# Access Compliance Report

## Public Rights-of-Way

Intersection ID: 2847	Main Street: BITTERBUSH_CT	Cross Street: WATERELM_LN	Location:	W
ADA ID: 824C00EA71E9	Ramp Type: Perp	Initial Pass/Fail: Fail	Overall Compliance: No	Severity Score: 47.5
Codes/Mitigation Info/Possible Solution		Field Measurements/Component Compliance

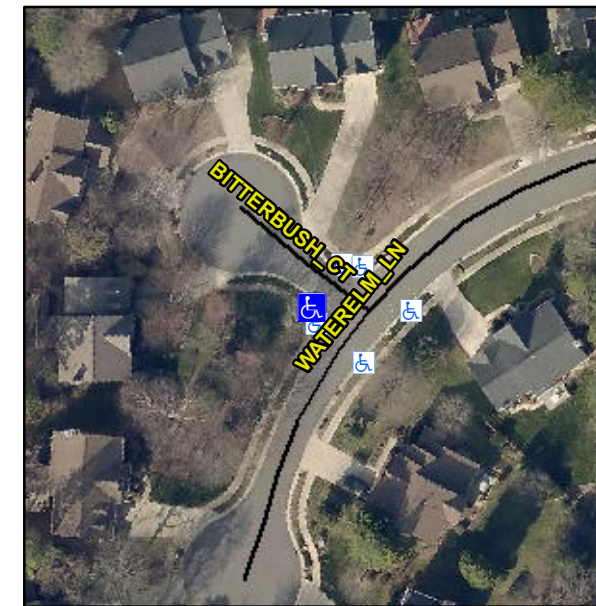
**Remove & Replace Entire Ramp.**

**Not Found, R304.5.1, R304.5.3**

Compliance	Description	Data	Compliance	Description	Data
N/A	Ramp Length (in)	48.0	Yes	Ramp Slope (%)	6.5
No	Ramp Width (in)	24.0	No	Ramp XSlope (%)	6.5
N/A	Flare Type LT	N/A	N/A	Flare Type RT	N/A
N/A	Flare Slope LT (%)	N/A	N/A	Flare Slope RT (%)	N/A
N/A	Flare Traversable LT?	N/A	N/A	Flare Traversable RT?	N/A
N/A	Landing Length (in)	N/A	N/A	DWS Provided?	N/A
N/A	Landing Width (in)	N/A	N/A	DWS Contrast?	N/A
N/A	Landing Slope (%)	N/A	N/A	DWS Length (in)	N/A
N/A	Landing X Slope (%)	N/A	N/A	DWS Full Width?	N/A
N/A	Landing Curb? (Y/N)	N/A	N/A	DWS Offset (in)	N/A
N/A	Shared Landing?	N/A			
N/A	Gutter Ponding?	N/A	N/A	Gutter Slope (%)	N/A
N/A	Gutter Lip Ht (in)	N/A	N/A	Gutter X Slope (%)	N/A
N/A	Painted X Walk1?	No	N/A	Painted X Walk2?	N/A
	X Walk 1 Direction	To NE		X Walk 2 Direction	N/A
N/A	X Walk 1 Width (in)	N/A	N/A	X Walk 2 Width (in)	N/A
	X Walk 1 Slope (%)	1.3		X Walk 2 Slope (%)	N/A
	X Walk 1 X Slope (%)	6.0		X Walk 2 X Slope (%)	N/A
